Alternative modeling scenarios and other considerations for Virginia Electric and Power Company's 2024 Integrated Resource Plan

Joshua D. Rhodes, PhD & Nicholas D. Laws, PhD

February 2025

Figure 17: Gas capacity trends 2024–2045 in VCEA WITH EPA RGGI, VCEA 2045 EPA RGGI 3X CLEAN 6X BESS, and VCEA 2045 EPA RGGI 3X CLEAN 6X NUCLEAR scenarios, broken down by existing and new installations.

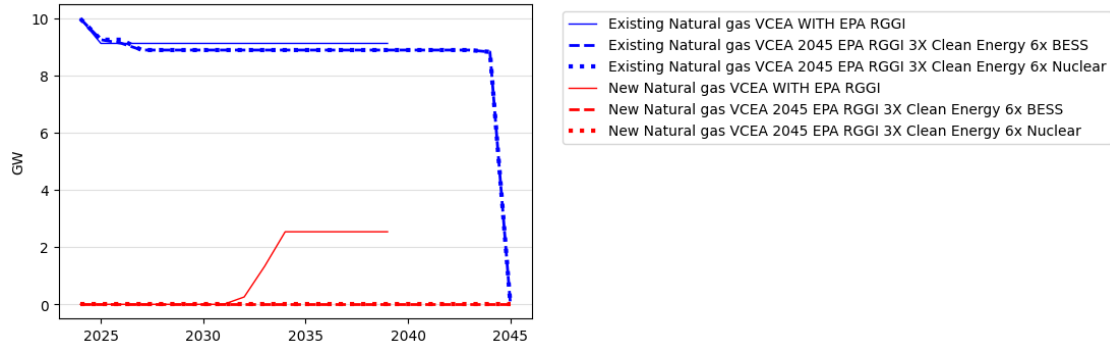
Figure 17 shows the gas capacity trends in the VCEA WITH EPA RGGI scenario (which ends in 2039) against the two 2045 scenarios with enough clean energy capacity to meet the zero-carbon requirement. Note that none of the VCEA-compliant 2045 scenarios install new gas, in contrast with all the 2039 scenarios that install the maximum amount of new CC gas generation.

Figure 18: Capacity changes by technology and year for the VCEA 2045 EPA RGGI 3X CE 6X BESS scenario.

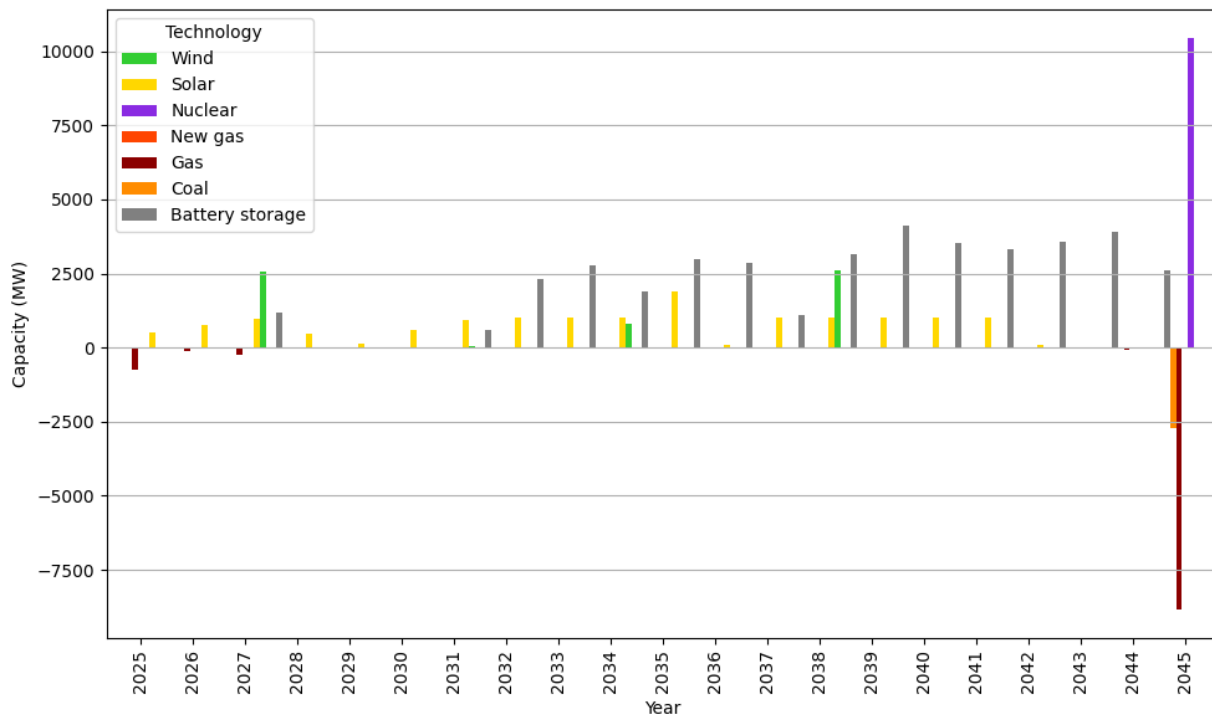
Figure 18 and Figure 19 show the capacity changes by technology in each year for the two scenarios that reach the zero-carbon requirement in 2045. These figures show that battery storage additions of a few GW before 2033 combined with additional renewable generation can preclude the need for new gas generation. Even in the 6X NUCLEAR scenario, the model installs battery storage earlier on in the planning horizon than nuclear.

Figure 20: Total present costs (\$B) for VCEA 2045 EPA RGGI, VCEA 2045 EPA RGGI 2X CLEAN, and VCEA 2045 EPA RGGI 3X CLEAN scenarios. **NOTE THAT THESE SCENARIOS DO NOT MEET THE 2045 ZERO-CARBON REQUIREMENT.** “RECs” is Renewable Energy Certificates.

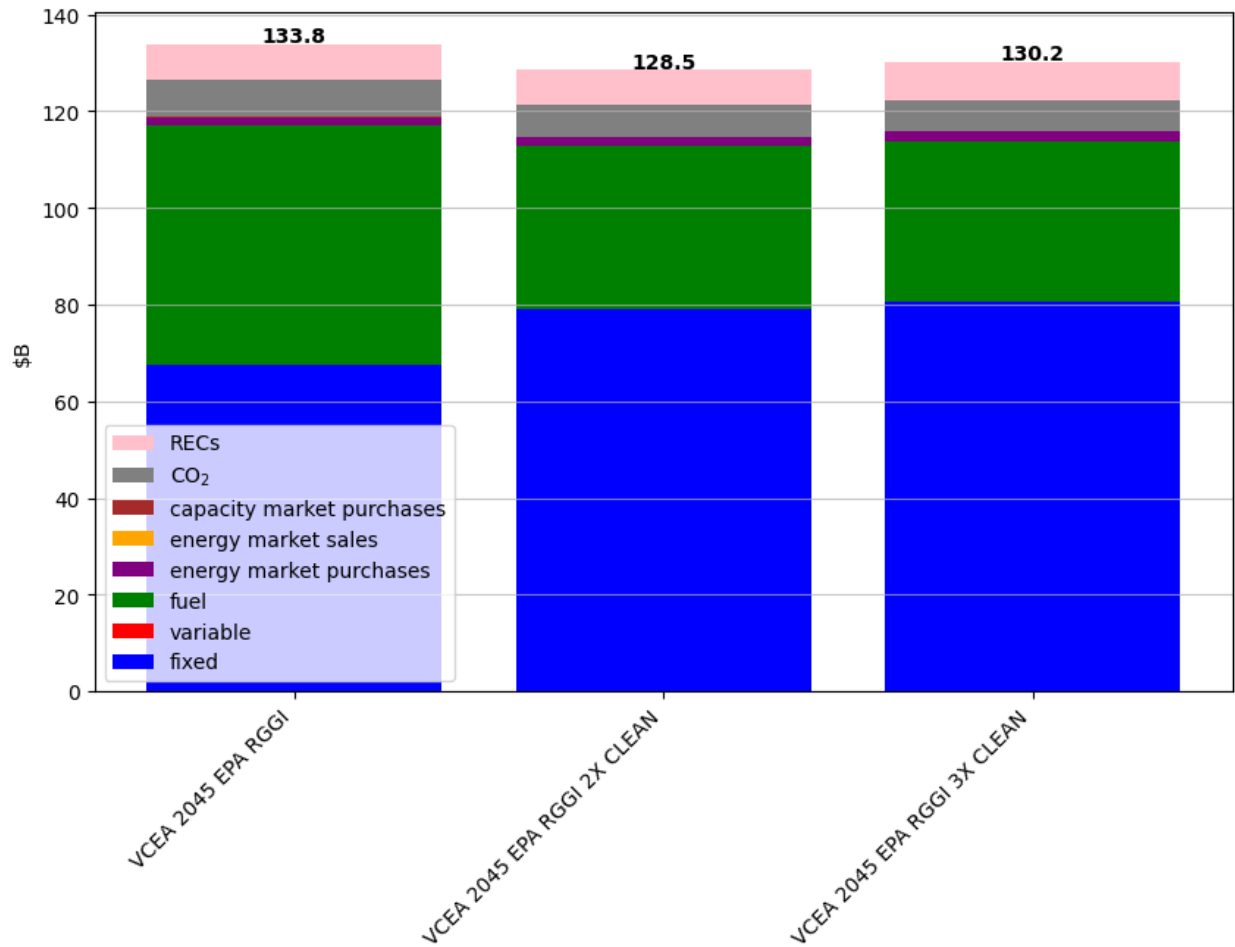
Figure 20 and Figure 21 show the total present costs for each of the 2045 scenarios. While the 6X BESS and 6X NUCLEAR scenarios have higher total costs than the other scenarios, it is important to note that the other scenarios do not meet the 2045 zero-carbon requirement. In fact, the additional costs in the 6X scenarios are primarily from fixed capital costs.

For example, the 2024–2045 present costs for the non-compliant VCEA 2045 EPA RGGI scenario are about \$12.7B lower than the compliant VCEA 2045 EPA RGGI 3X CLEAN 6X BESS case (see Figure 20 and Figure 21). However, the fuel costs in 2045 for the non-compliant VCEA 2045 EPA RGGI scenario are about \$3.48B *higher* than the compliant 6X BESS scenario. Assuming these values carried forward, it is possible that the total costs of the 6X scenarios could be at or lower than the total costs of non-compliant cases as soon as a few years past 2045. However, one would need to model further into the future to assess this possible outcome.

Also note that the costs in Figure 20 and Figure 21 do not include the damages discussed in **Section: Environmental Justice**, which show that the damages from NO_x, SO₂, and PM_{2.5} emissions are non-trivial, but would decline to \$0 (from the power sector) when the model reaches 2045 in the 6X scenarios.

Figure 22: Figure showing fuel costs in 2045 for all 2045 scenarios.

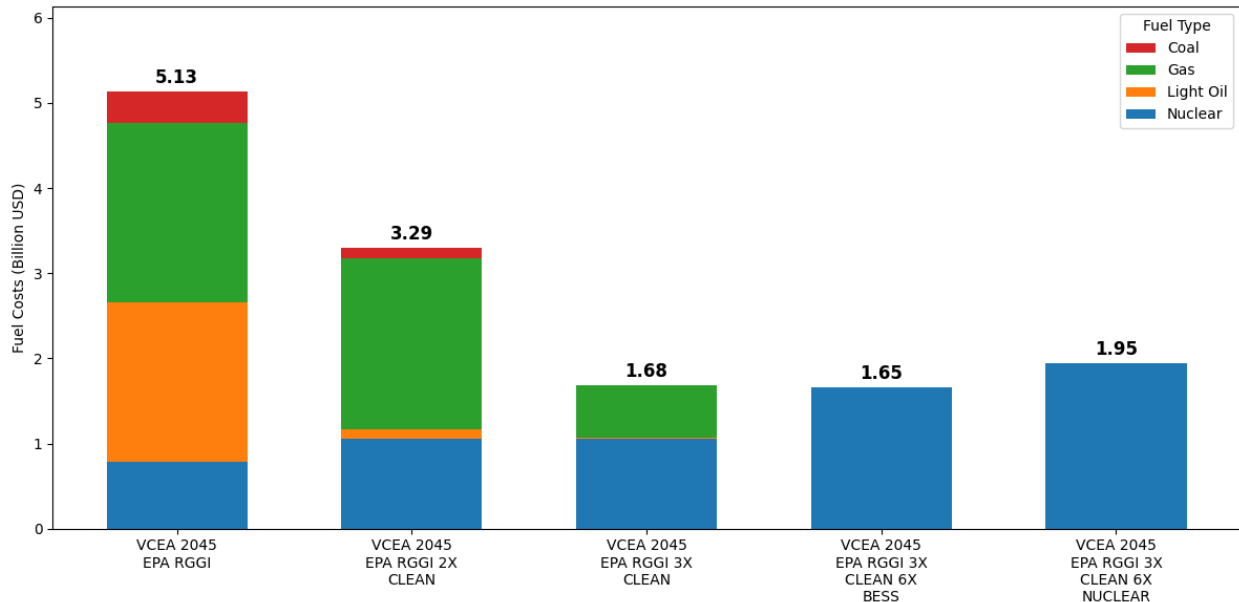
Figure 22 shows that fuel costs drop significantly in the 6X scenarios in 2045 when the zero-carbon requirement is met, while fuel costs remain higher in the non-compliant scenarios.
